Product Change Notification (PCN)

PCN #: 11B-2021

DATE: 25th November 2021

5.1 Back Product Label (on device)

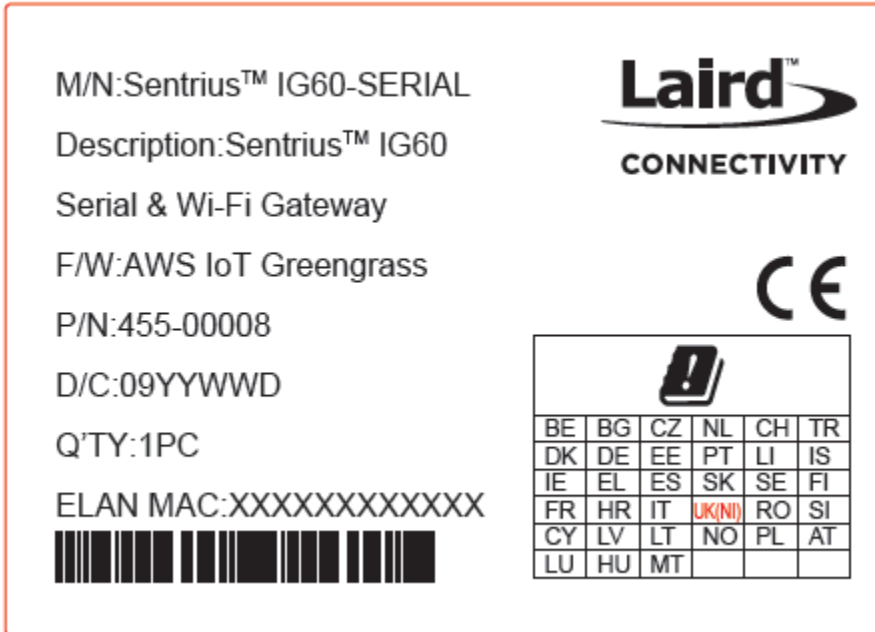
- Addition of UKCA logo on the back product label, where it can be accommodated.
